Product Notification: R-net CJSM2 – IR Configurator Library Codes

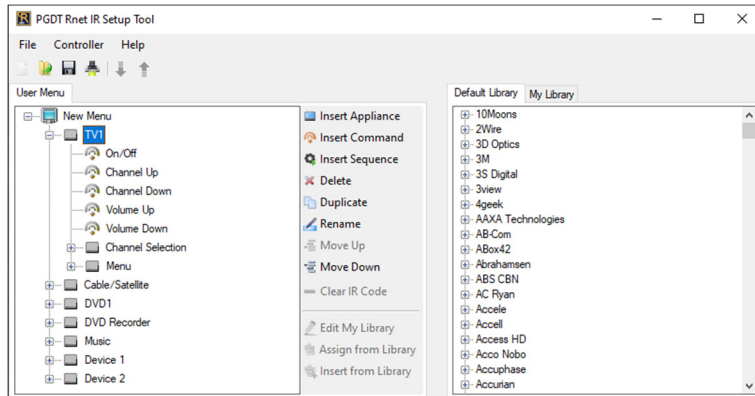
We regret to inform you, that due to an unavoidable, critical component change in Curtiss-Wright's CJSM2 Joystick Modules (JSMs), implemented to ensure uninterrupted product supply, it will no longer be possible to insert Library Codes from the R-net PC Programmer IR Configurator utility (pictured above).

The ability to learn IR codes from IR handsets is unaffected by this change. For additional information on IR learning and library codes, please refer to the CJSM2 Technical Manual SK81302, Chapters 4 and 5 respectively.
